M12 Motorway

Amendment Report

October 2020

Figure A-1 Key features of the amended project

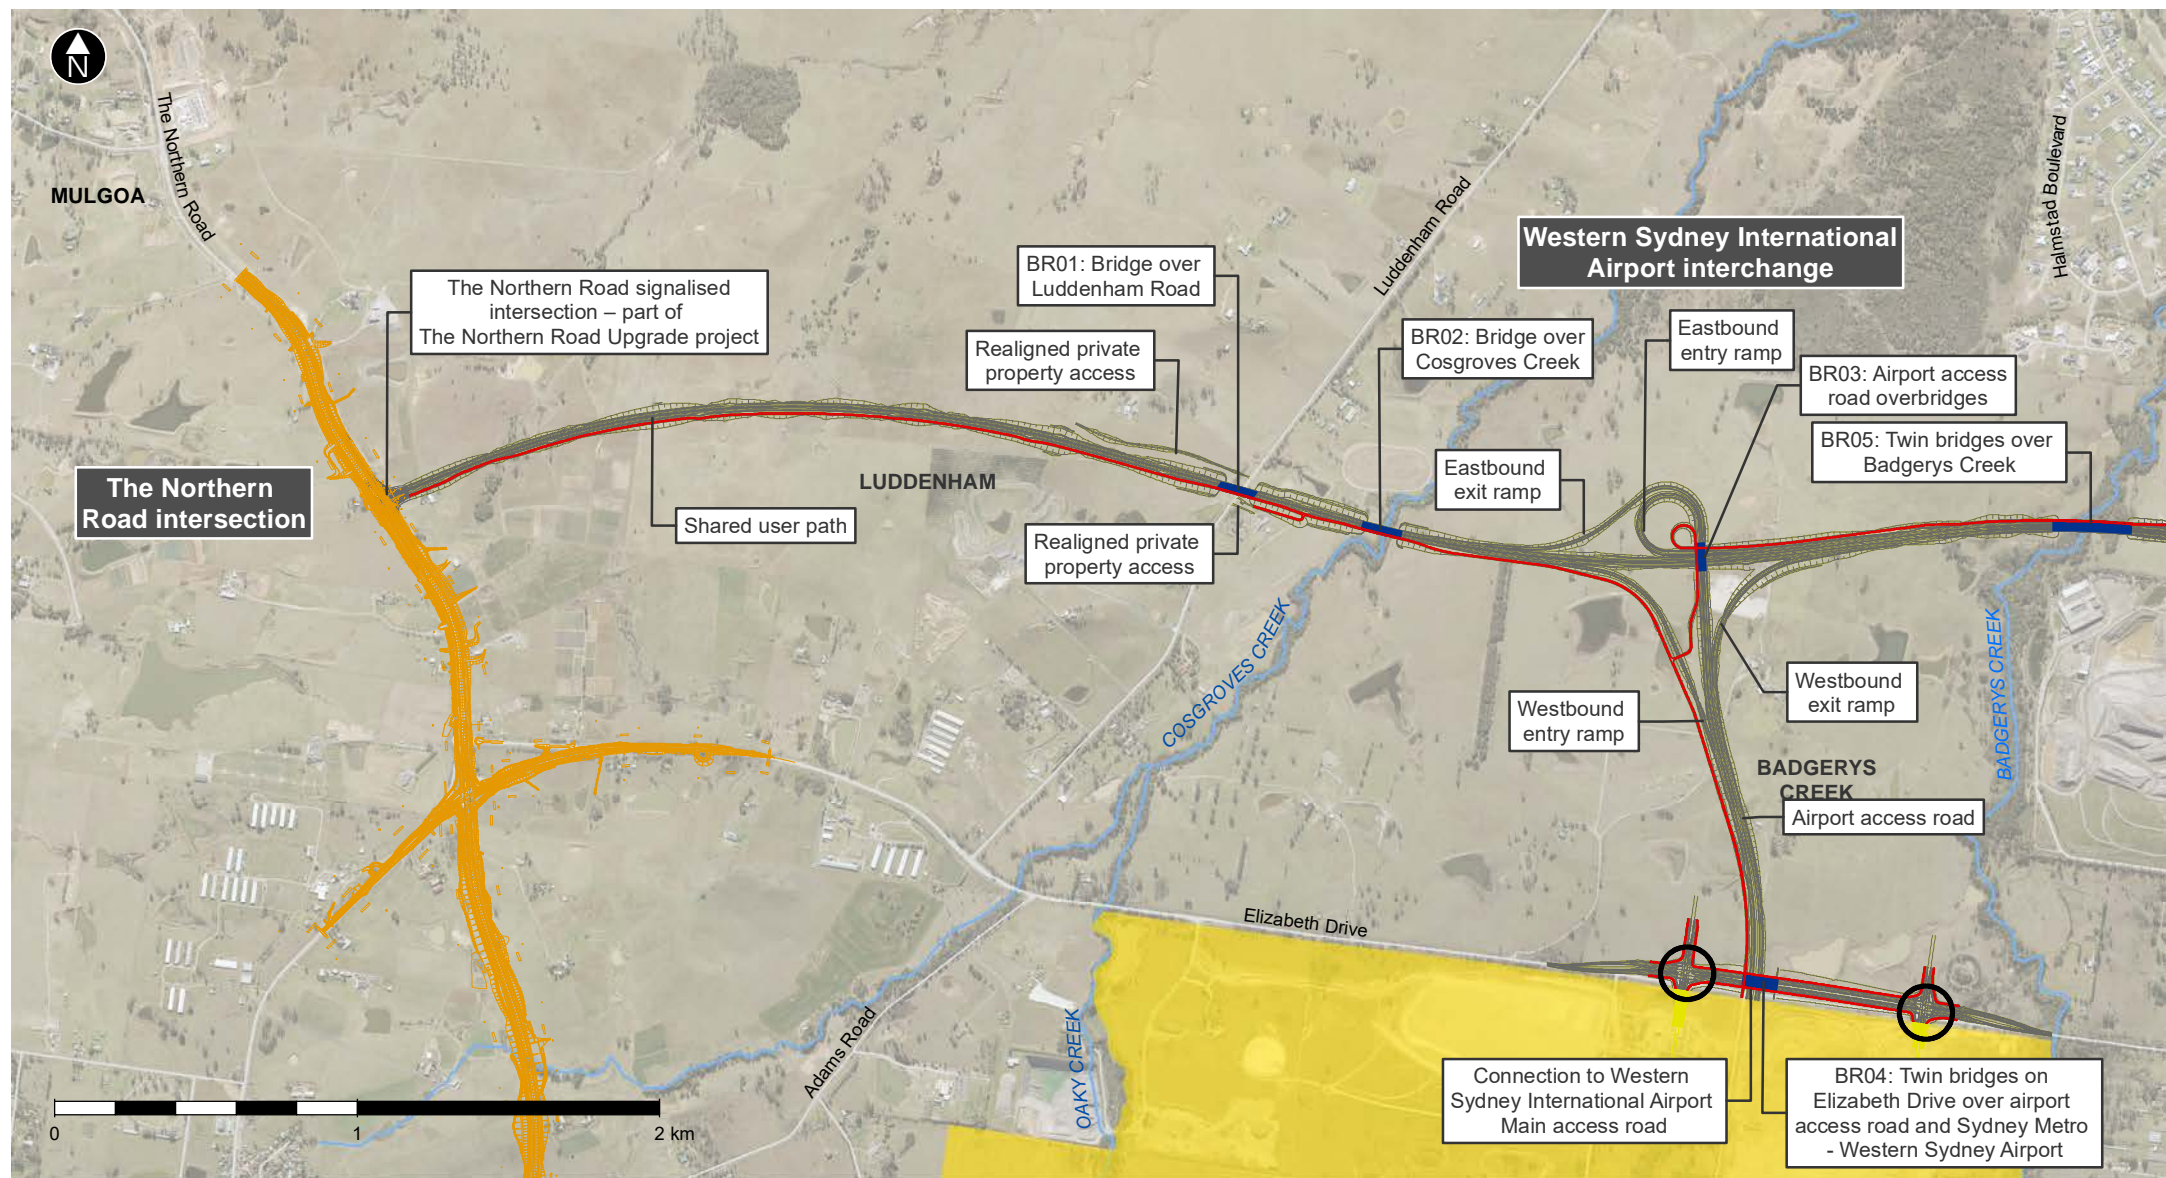
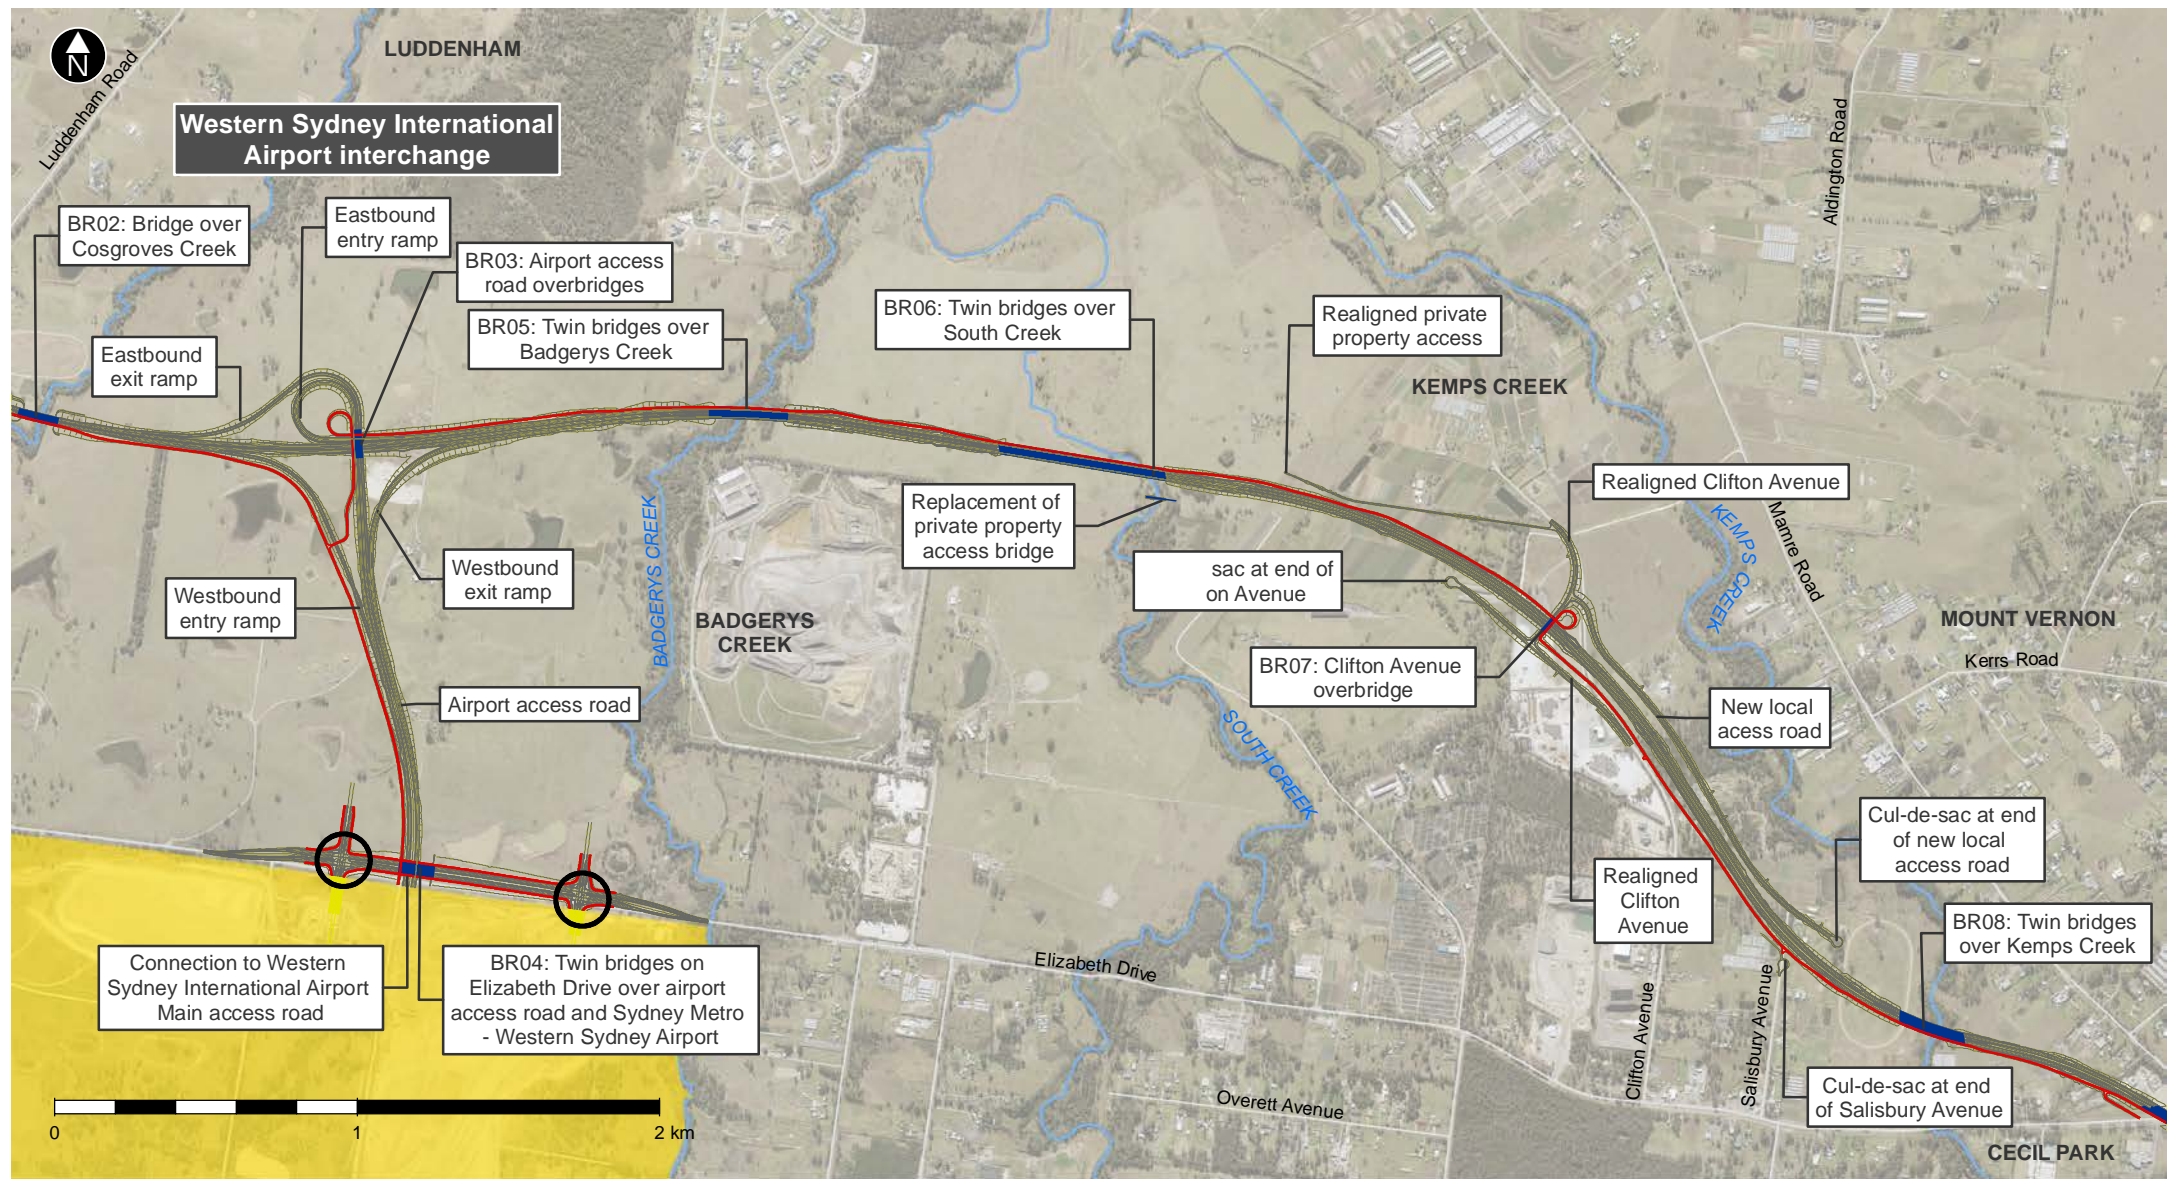
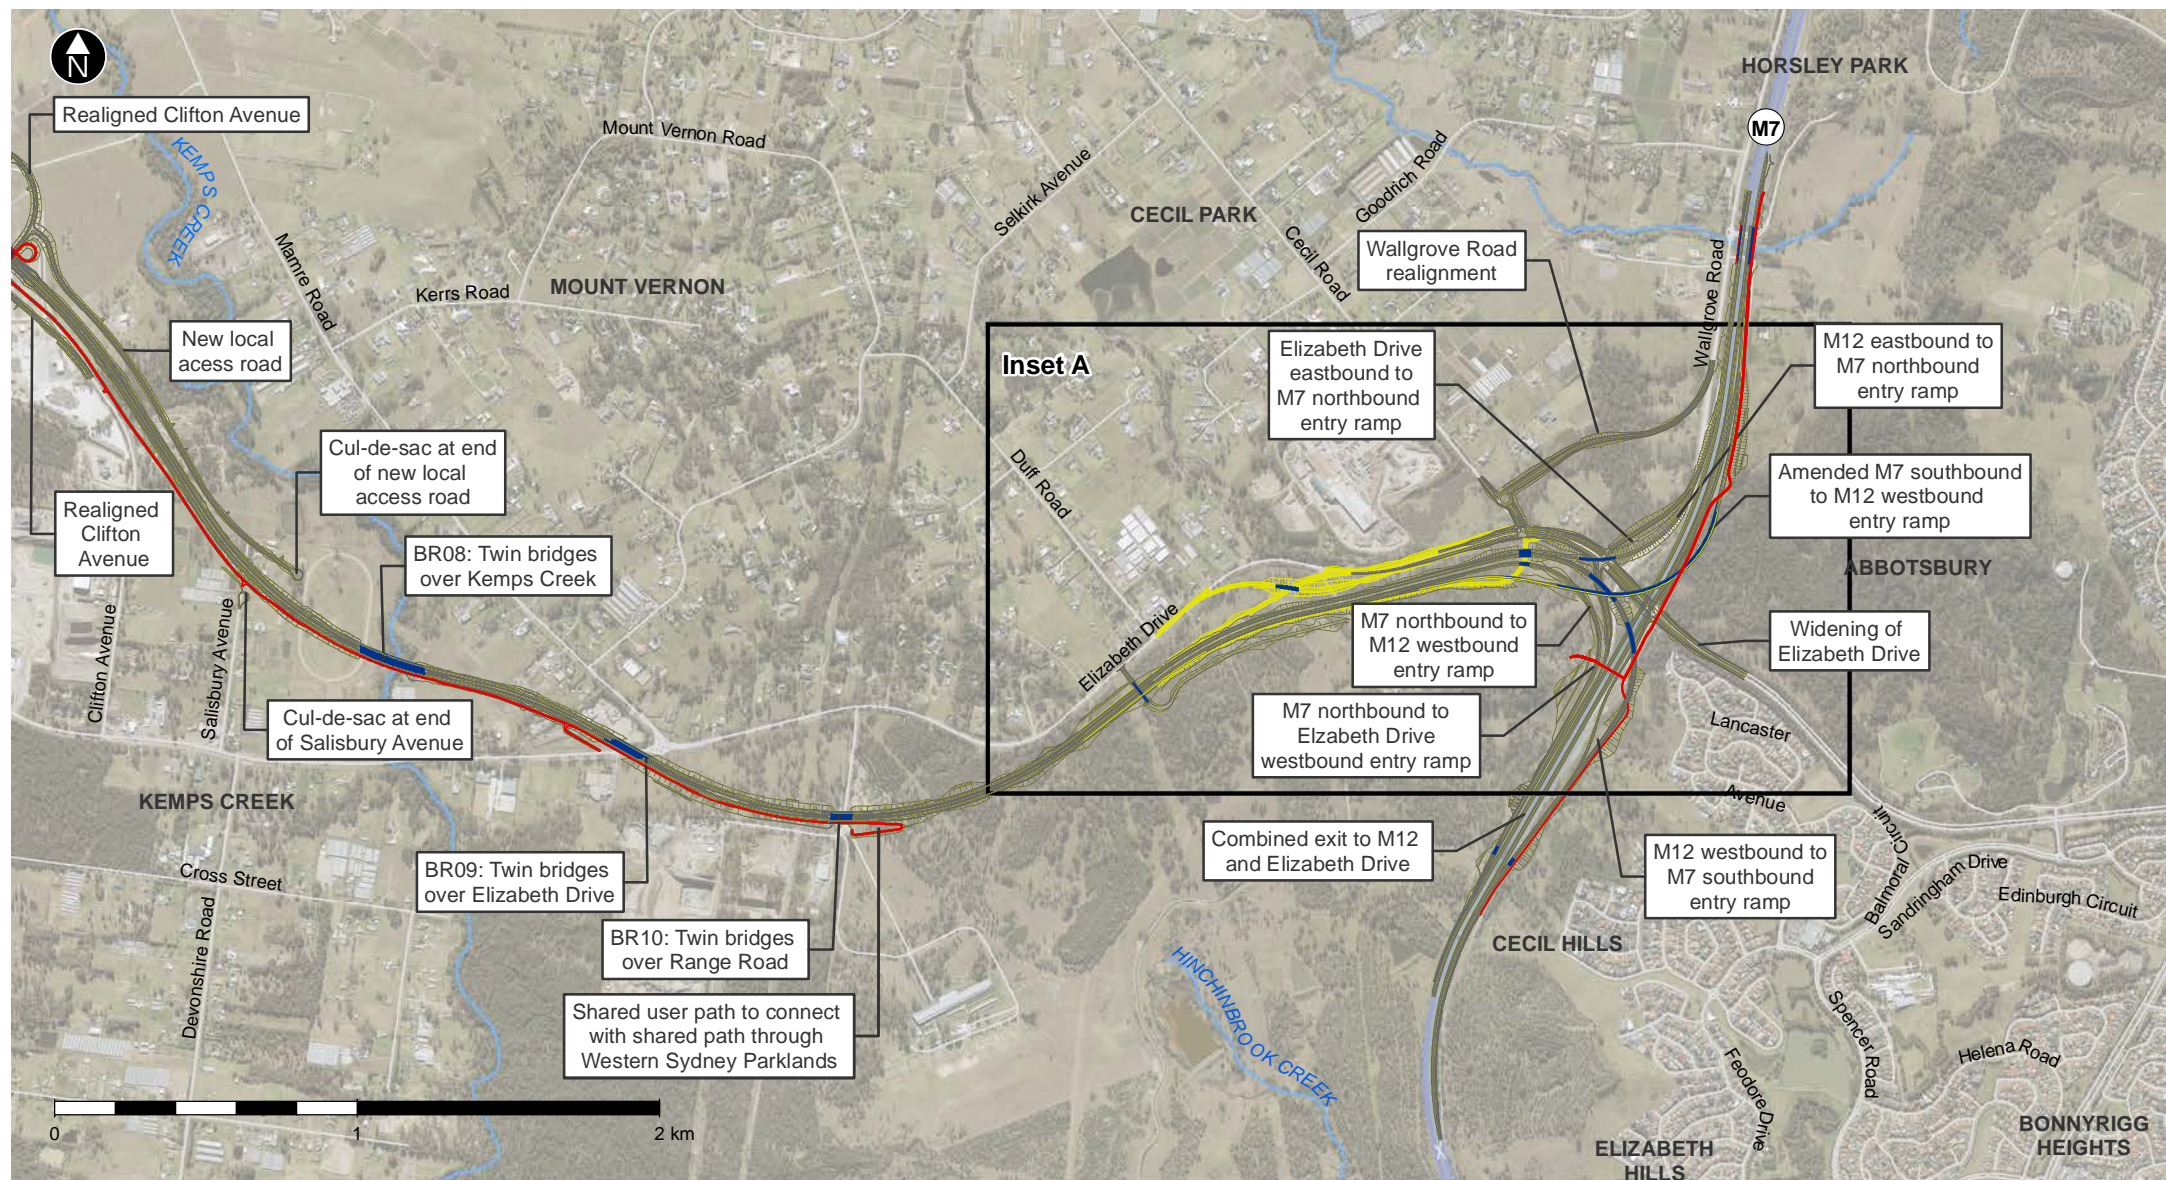
The key features of the amended project are listed below and shown in **Figure A-1**.

- A new dual-carriageway motorway between the M7 Motorway and The Northern Road with two lanes in each direction with a central median allowing future expansion to six lanes

- Motorway access via three interchanges/intersections:
 - A motorway-to-motorway interchange at the M7 Motorway and associated works (extending about four kilometres within the existing M7 Motorway corridor) with the following options:

- Option 1 – without connection between the M12 Motorway and Elizabeth Drive
 - Option 2 – with connection between the M12 Motorway and Elizabeth Drive (Note: The decision on which option would be built is dependent on funding being available to include the Elizabeth Drive connection).

- A grade-separated interchange referred to as the Western Sydney International Airport interchange, including a dual-carriageway four-lane airport access road (two lanes in each direction for about 1.5 kilometres) connecting with the Western Sydney International Airport Main Access Road

- Modifications to the local road network, as required, to facilitate connections across and around the M12 Motorway including:
 - Realignment of Elizabeth Drive at the Western Sydney International Airport, with Elizabeth Drive overpassing the airport access road and rail infrastructure

- Two new signalised intersections from Elizabeth Drive into the Western Sydney International Airport, with provisions for future connection to potential developments to the north

- Widening of Elizabeth Drive under the M7 Motorway and approaches
 - Realignment of Clifton Avenue over the M12 Motorway, with associated adjustments to nearby property access

- Relocation of Salisbury Avenue cul-de-sac, on the southern side of the M12 Motorway
 - Realignment of Wallgrove Road to connect to Cecil Road, including a connection between Elizabeth Drive and Wallgrove Road via Cecil Road with a signalised intersection with Elizabeth Drive
